Proposal for amendments to ECE/TRANS/WP.29/2017/10

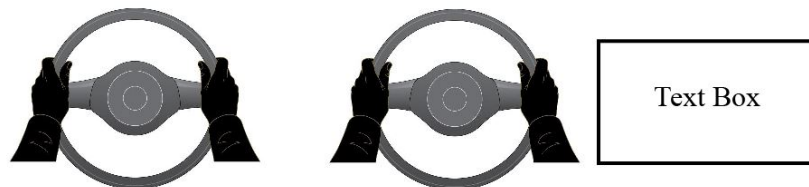
The optical warning signal shall indicate to the driver to place their hands on the steering control. It shall consist of pictorial information showing hands and the steering control and may be accompanied by additional explanatory text or warning symbols- see examples below:

If, after a period of no longer than 30 seconds the driver is not holding the steering control, **an acoustical warning shall be provided in addition to the signal mentioned above at least the hands or steering control in the pictorial information provided as optical warning signal shall be shown in red and an acoustic warning signal shall be provided.**
